# Access Compliance Report Public Rights-of-Way (RR Crossings)

| Intersection ID: 13985                  | Main Street: CAMDEN_RD | Location: N/A                           |
| ADA ID: 92DF784B6E44                    | Overall Compliance: No | Severity Score: 0.0                     |

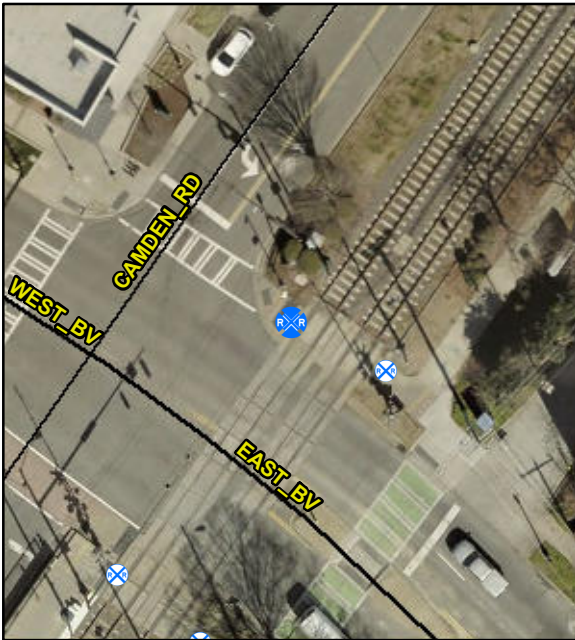
**Remove & Replace Detectable  
Warning System. Provide Pedestrian  
Gate. Remove & Replace Walking  
Surface Adjacent to Rail.**

**R302.7.4, R305.2.5**

| Compliance | Description         | Data      |
|------------|---------------------|-----------|
| No         | DWS Offset (in)     | 18.0      |
| No         | Pedestrian Gate?    | No        |
| No         | Flangeway Gap (in)  | 3.0       |
